Lee's Summit Plan Review
220 SE Green Street
Lee's Summit, Missouri 64063
816-969-1200

RE: CITY COMMENTS FOR PRCOM20231142

Everstead Engineering & Design, LLC has updated the above-mentioned property construction documents per city comments as follows:

GENE INSOGNIA
TENANT FINISH
3512 SW MARKET ST
LEES SUMMIT, MO 64082

G201

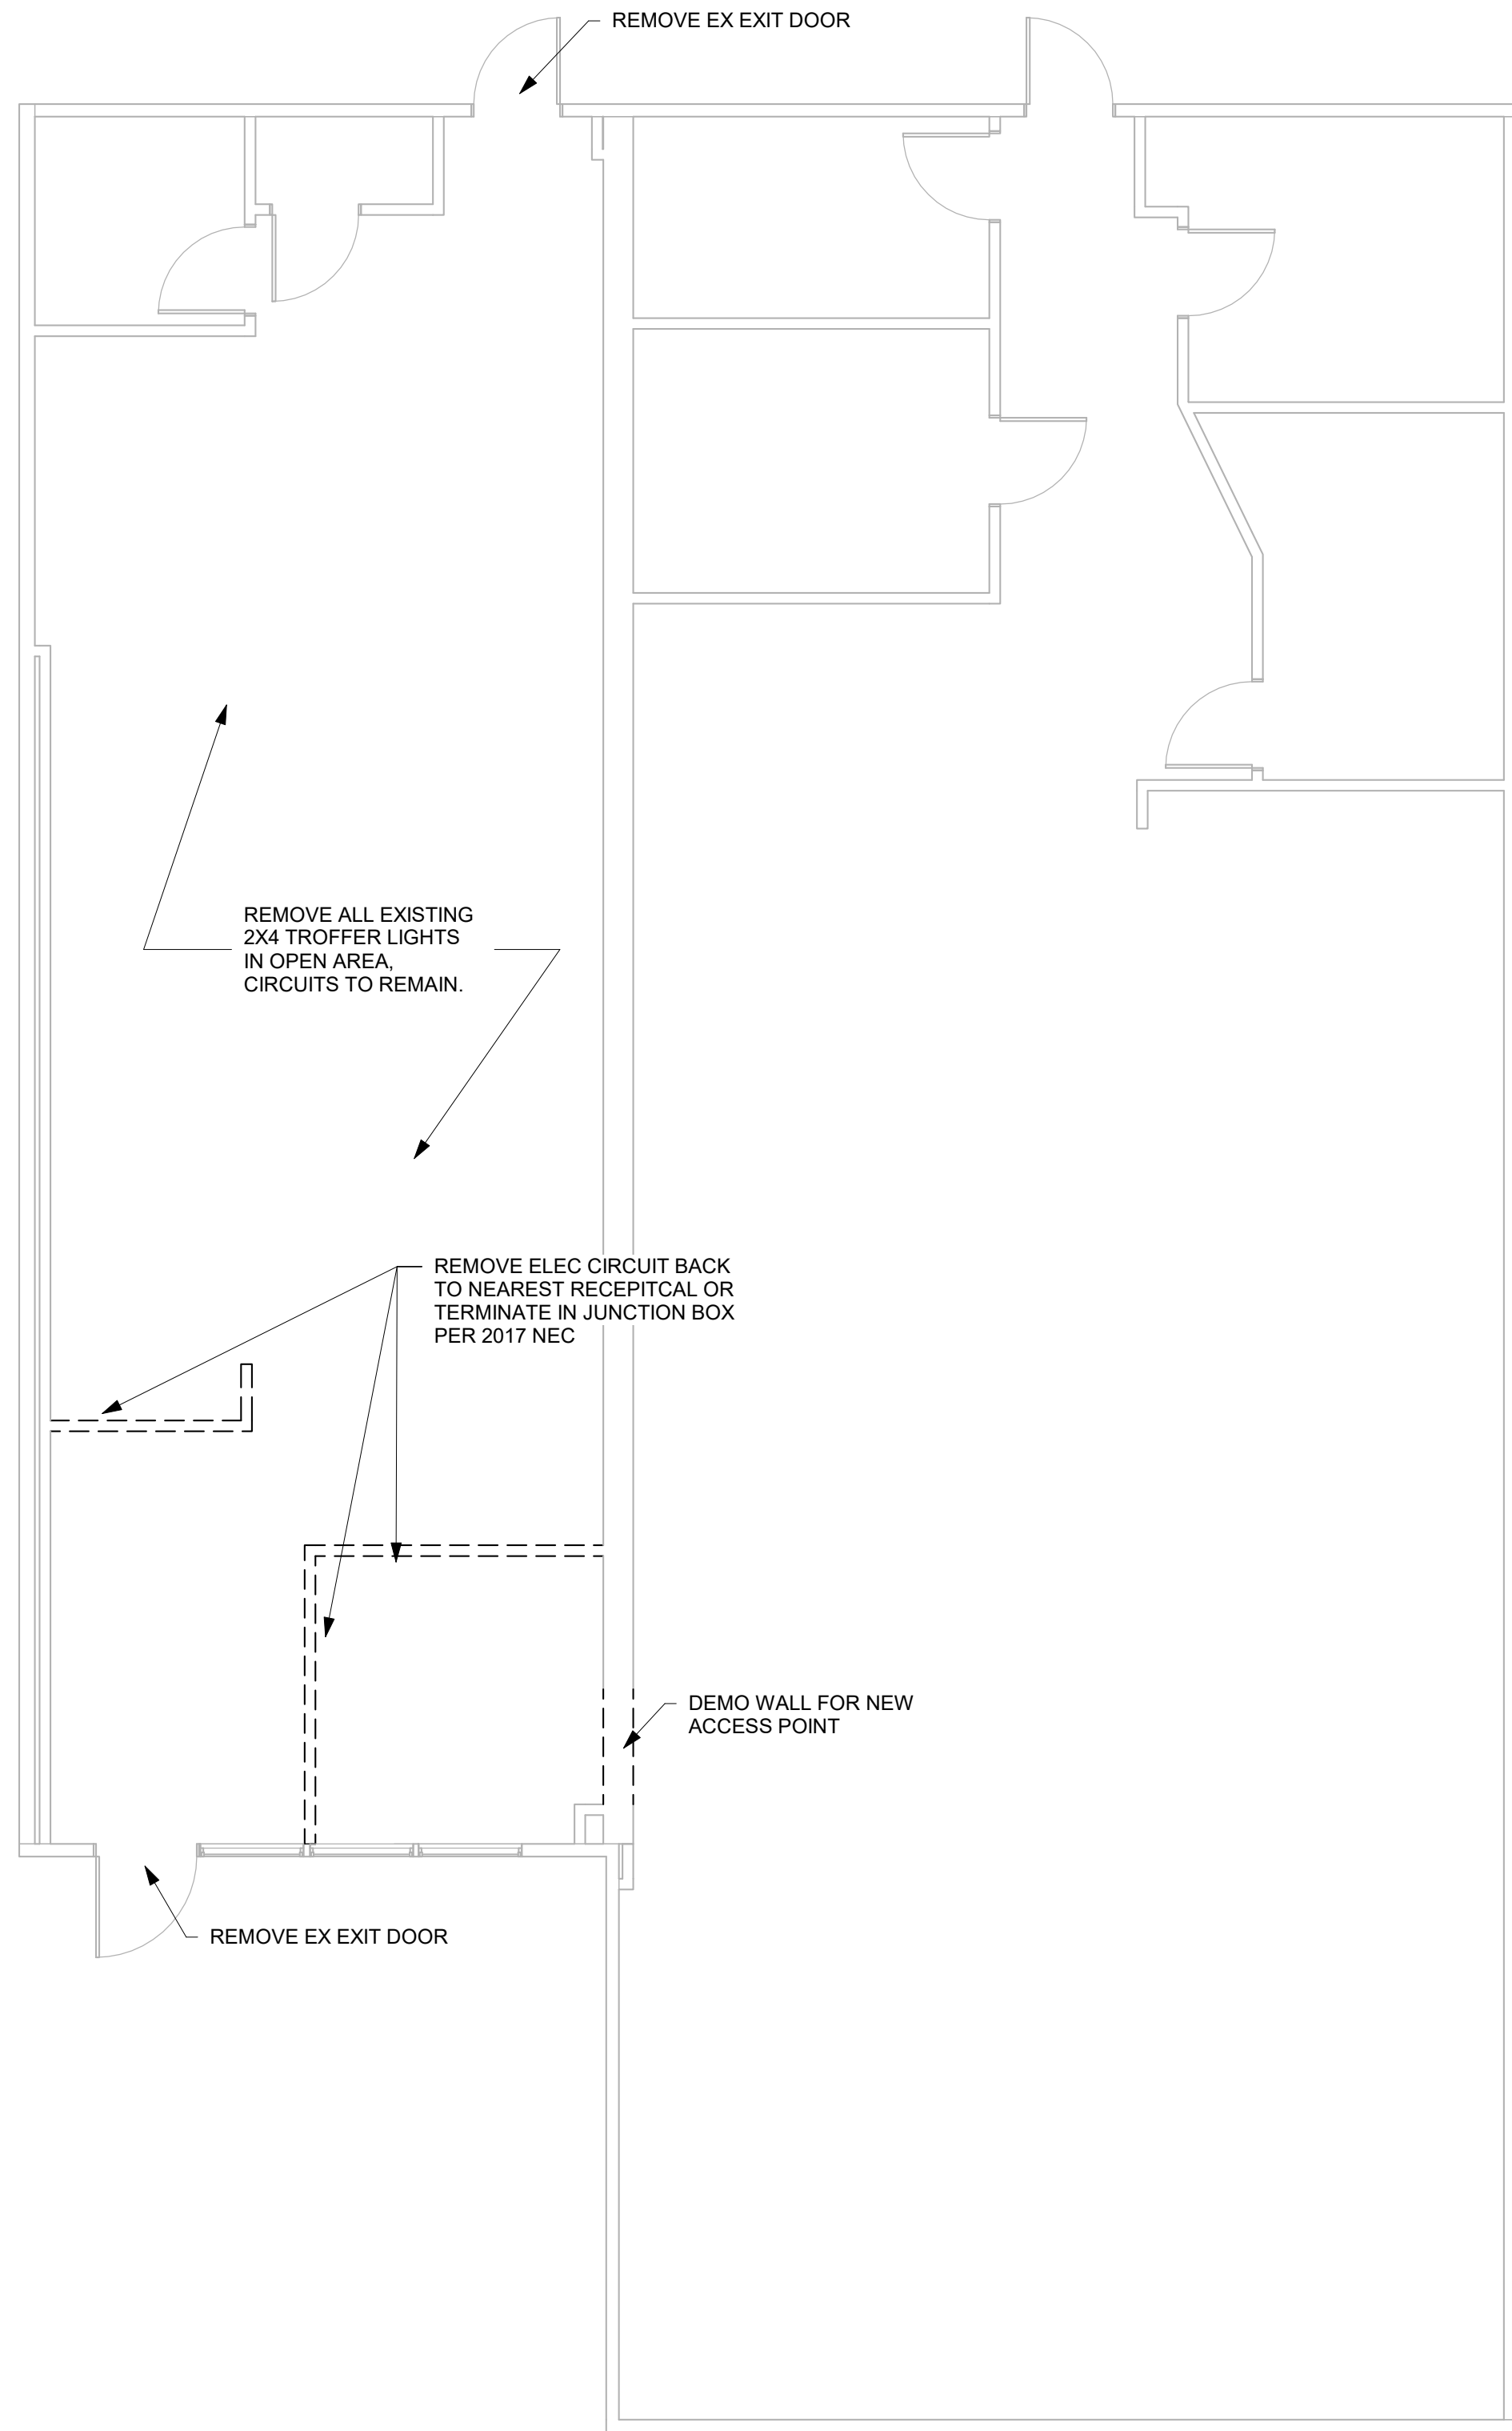
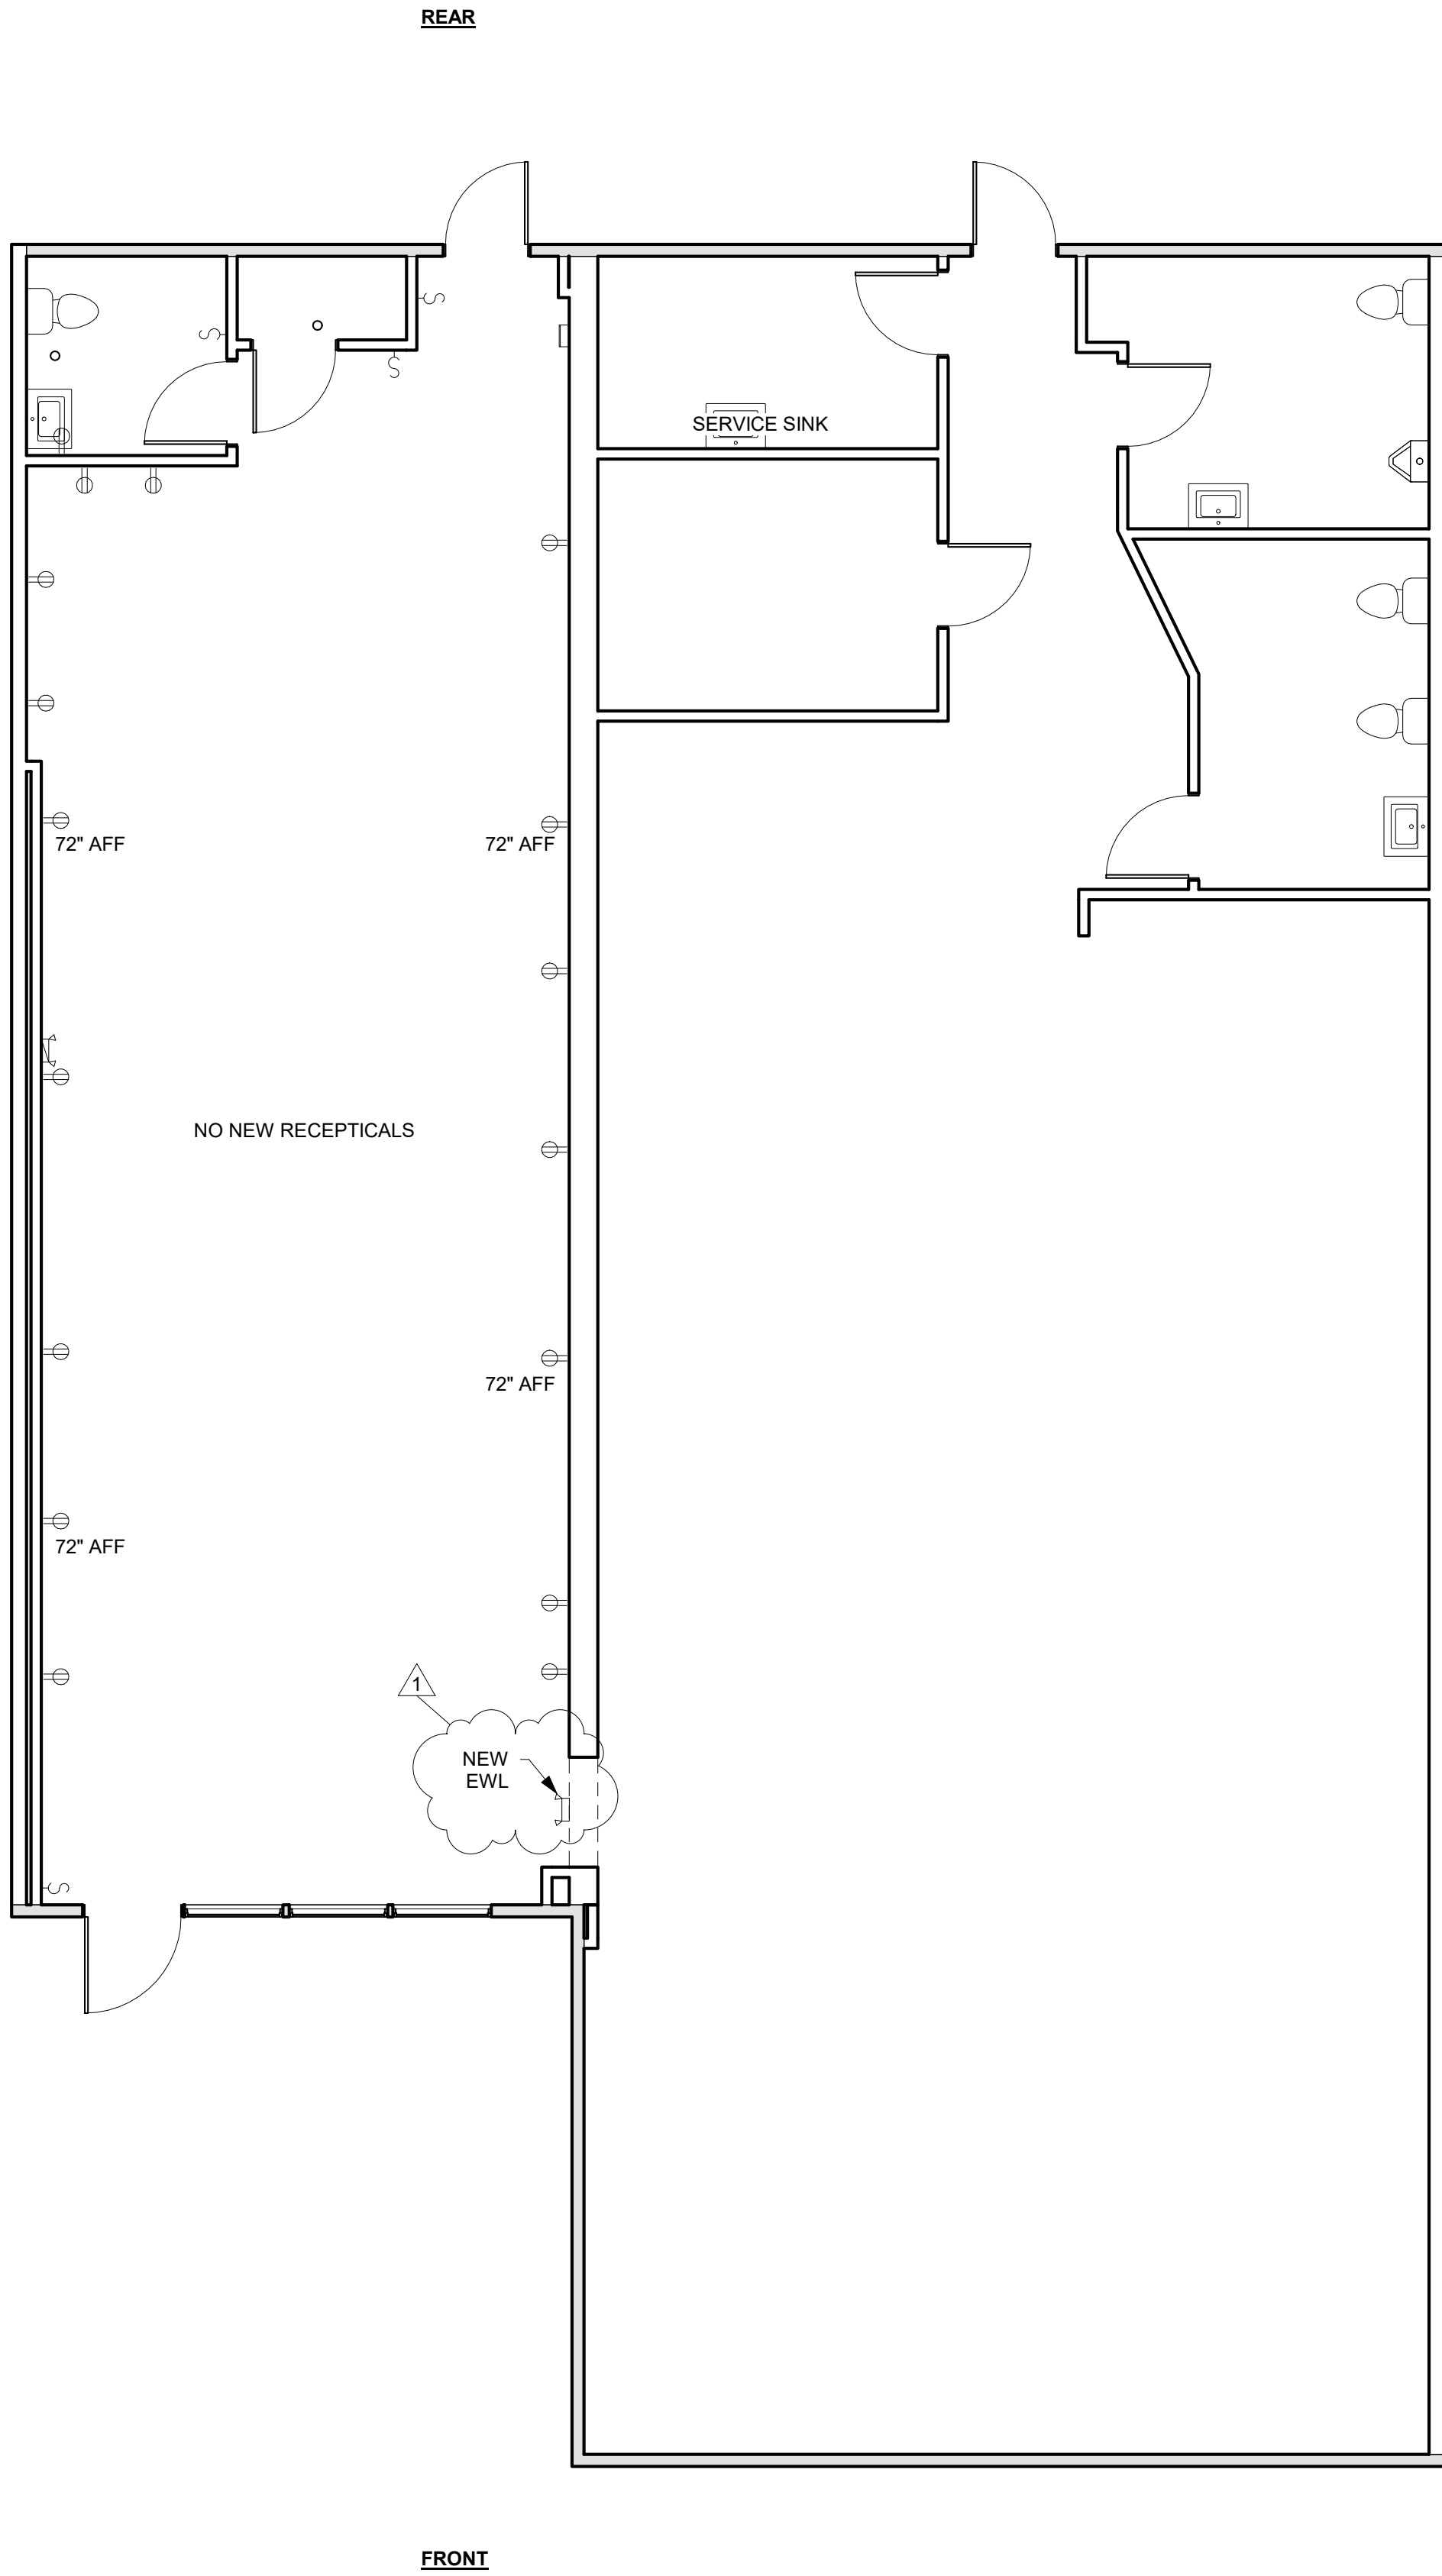
City Comment #2 "2018 IBC 1010.1.2 Door swing. Egress doors shall be of the pivoted or side-hinged swinging type. Exceptions: (See code for exceptions.)
2018 IBC 1010.1.2.1 Direction of swing. Pivot or side-hinged swinging doors shall swing in the direction of egress travel where serving a room or area containing an occupant load of 50 or more persons or a Group H occupancy."

City Comment #2 "2018 IFC 906.2- General requirements. Portable fire extinguishers shall be selected, installed and maintained in accordance with this section and NFPA 10."

City Comment #3 "2018 IFC 1010.1.2.1 Direction of swing. Doors shall swing in the direction of egress travel where serving a room or area containing an occupant load of 50 or more persons or a Group H occupancy."

City Comment #6 "What is the width of the new cased opening and what is the exiting capacity of the existing space? The exit on the front of the existing space is not shown."

Engineer's Response – Door swing has been corrected, G201 updated.

Engineer's Response – General placement of fire extinguisher noted on G201.

Engineer's Response – Front door swing has been corrected.

Engineer's Response – New cased opening is shown as 48 inches wide, G201. No action taken.
